FIRST AVENUE PROPERTIES REZONING
with Modifications Proposed by New York City Council

Technical Memorandum

CEQR No.: 06DCP039M

March 24, 2008

685-700-708 First Avenue
Building Heights
Figure 2

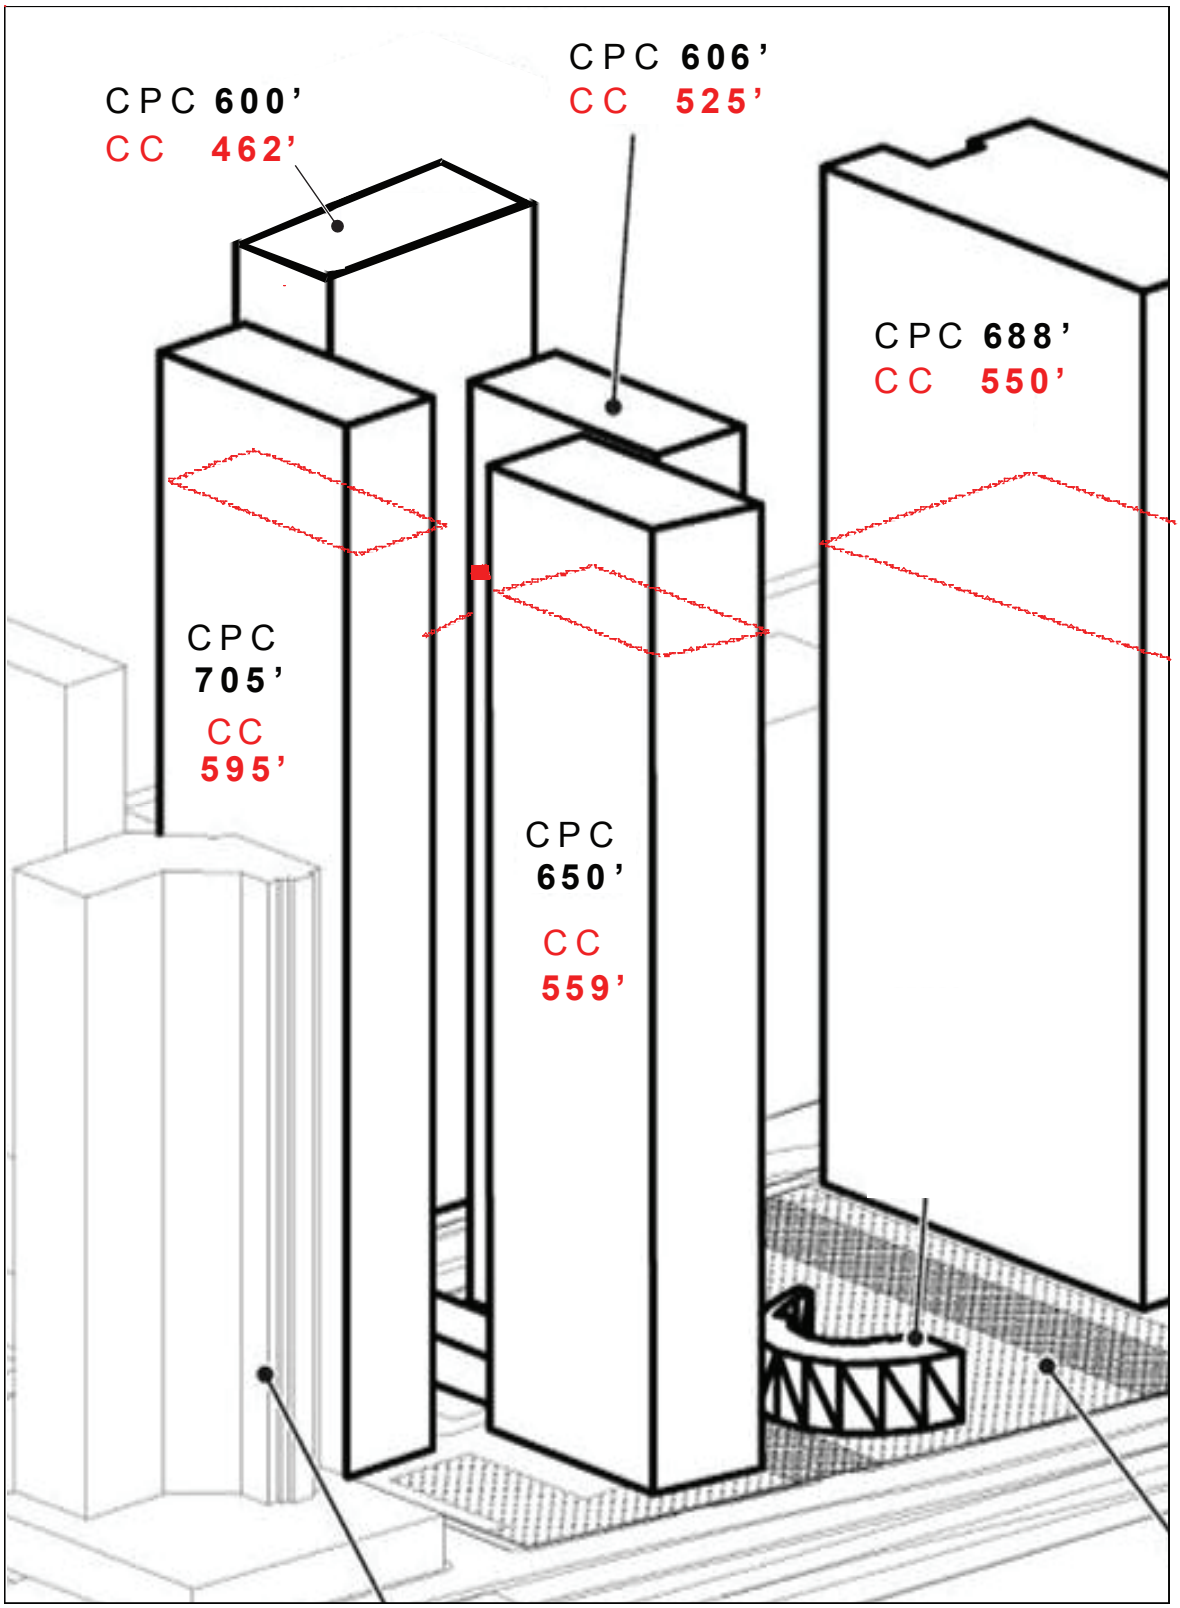
The City Council's proposed modifications would further reduce the total zoning floor area to approximately 4.38 million square feet, would reduce the heights of buildings on the 685, 700, and 708 First Avenue parcels (shown in Figure 2, below), would increase the amount of publicly accessible open space over that examined in the FSEIS by between 6,500 and 7,500 square feet, would further decrease the number of parking spaces, would provide for a new open space amenity east of the 708 First Avenue building, and would modify the proposed building placement, public school site, and public open space configuration at the 616 First Avenue site. With the CPC-approved and proposed City Council modifications, the overall floor area ratio (FAR) of the Proposed Actions would be reduced from 12 to 10.26.

The City Council proposes to further reduce the height of the 685 First Avenue building from 600 feet (as approved by CPC) to 462 feet. The zoning floor area of the building would be reduced to 793,644 square feet, from 968,124 square feet in the FSEIS (a reduction to 9.84 FAR from 12.0 FAR), and the number of dwelling units would be reduced from 1,066 to 856. The building would comply with all other CPC-approved modifications noted above, and there would be no publicly accessible open space on the site.

The City Council proposes to reduce the height and floor area of each of the three residential towers at 700 First Avenue. The tower on the southwestern portion of the site (WS1-1 on Figure 3) would be 595 feet tall, as compared to 705 feet in the FSEIS development program. The tower on the eastern portion of the site (WS1-2) would be 559 feet, as compared to 650 feet in the FSEIS development program. The northernmost tower (WS1-2) would be 525 feet, as compared to 606 feet in the FSEIS. Collectively, the buildings would be reduced approximately to 1.71 million zoning square feet of residential space (1,996 units). The proposed modifications would reduce the overall FAR on the 700 First Avenue parcel from 12.0 to 10.53. The amounts and locations of ground-floor retail and below-grade retail space would remain as analyzed in the FSEIS.

The City Council proposed modifications would further reduce the allowable zoning floor area of the building at 708 First Avenue from approximately 1.15 million square feet to approximately 1.05 million square feet, an overall reduction of 328,818 zoning square feet as compared to the building analyzed in the FSEIS. This change would reduce the FAR from 10.0 to 9.13 at this site. The modifications also require a height reduction to 550 feet, as compared to a 688-foot building height analyzed in the FSEIS. The building footprint would retain the same rectangular shape imposed by the CPC modifications; the approximate dimensions are 280 feet by 145 feet (see Figure 3).

Site Plan with all Modifications
Option 1 at 616 First Avenue
Figure 3

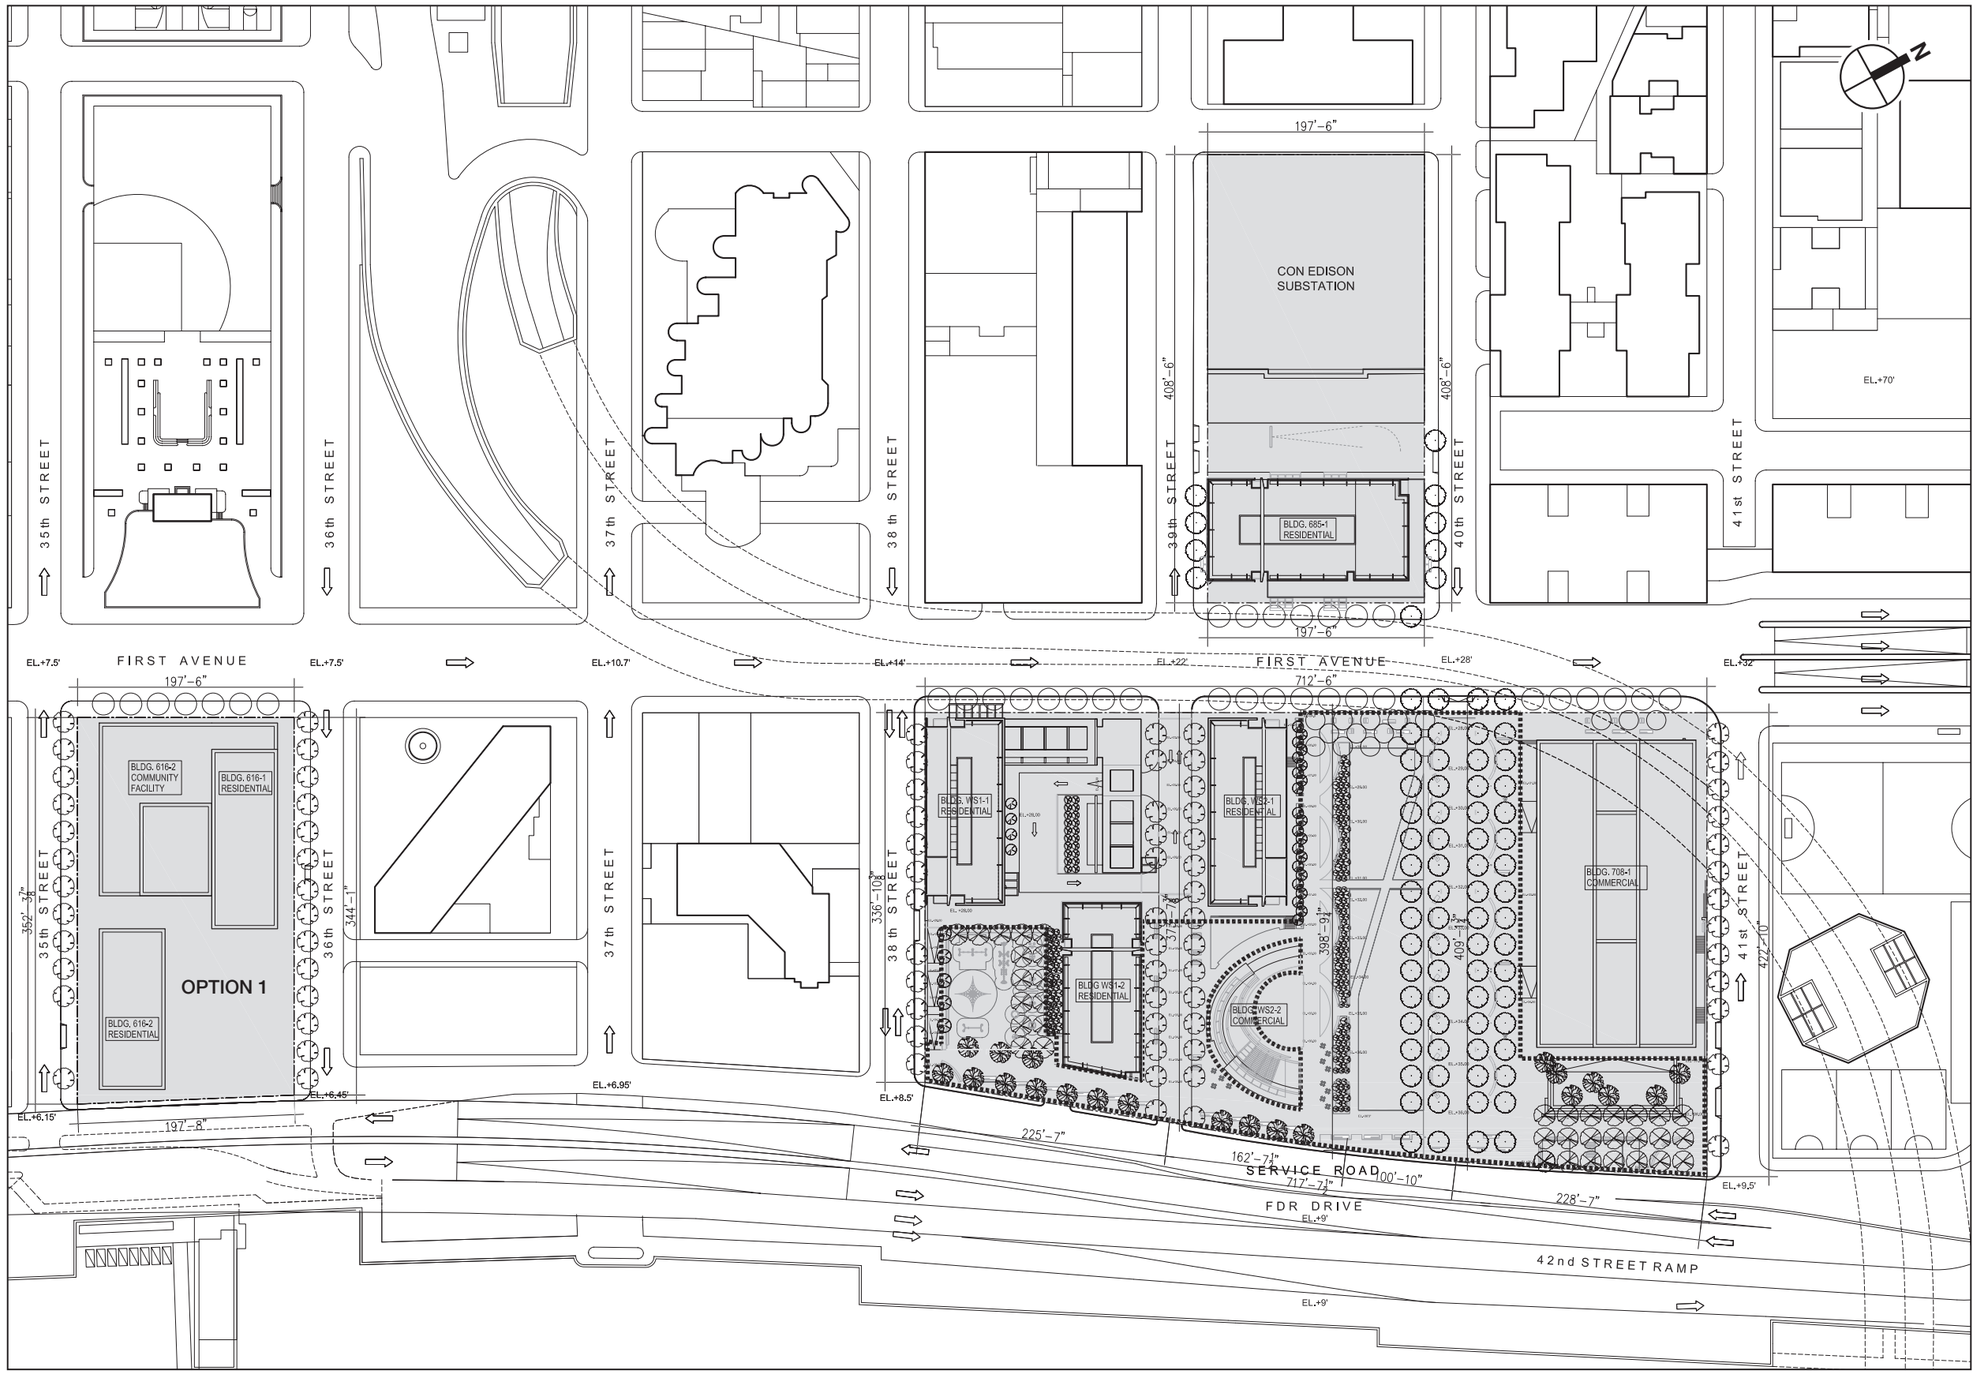
The proposed modifications to the site plan at 616 First Avenue would change the location of buildings on the site and reorient the buildings so that the school building would be located along First Avenue and both predominantly residential buildings would be placed on an east-west orientation (see Figures 3 and 4). The open space on 616 First Avenue would be further reduced and would be moved from the center of the site to the northeast corner of the site, along East 36th Street.

Similar to the CPC-approved program, the site plan at 616 First Avenue continues to reflect the possibility that the school would be in a free-standing structure immediately adjacent to the residential building along First Avenue (the 616-1 building in Figures 3 and 4). As shown in Table 1, there would be no difference in total zoning floor area and minor differences in uses if the school was at the base of the residential building (616-Option 1) or a freestanding structure (616-Option 2). Depending on the Option, there would be between 2,130 and 3,200 square feet less zoning floor area for residential use, and between 2,130 and 3,200 square feet more zoning floor area for retail use. Option 2 would have slightly more retail zoning floor area than Option 1, because of the size, placement, and design of the base of each of the three freestanding buildings. The amount of open space would also vary slightly between the two options—18,099 square feet plus a sidewalk enlargement of 11,412 square feet for a total of 29,511 square feet under Option 1 and 19,974 square feet under Option 2 plus a sidewalk enlargement of 8,524 for a total of 28,498 square feet. The proposed City Council modifications would not change the school's construction schedule and the September 2012 opening date would be unchanged.

The City Council proposed modifications to the site design at 616 First Avenue would relocate and further reduce the publicly accessible open space on the site. The open space configuration and area would differ between Option 1 and Option 2. In connection with the repositioning of the buildings, the open space on 616 First Avenue would be moved from the center of the site to the northeast corner of the site, along East 36th Street under both options. As shown on Figures 3 and 4, under Option 1, the public open space area would be 18,099 square feet (0.42 acres); Option 2 would make available an additional 1,875 square feet, for a total open space area of 19,974 square feet (0.46 acres). The total open space under Option 1 would be 29,511 square feet; the total open space under Option 2 would be 28,498 square feet.
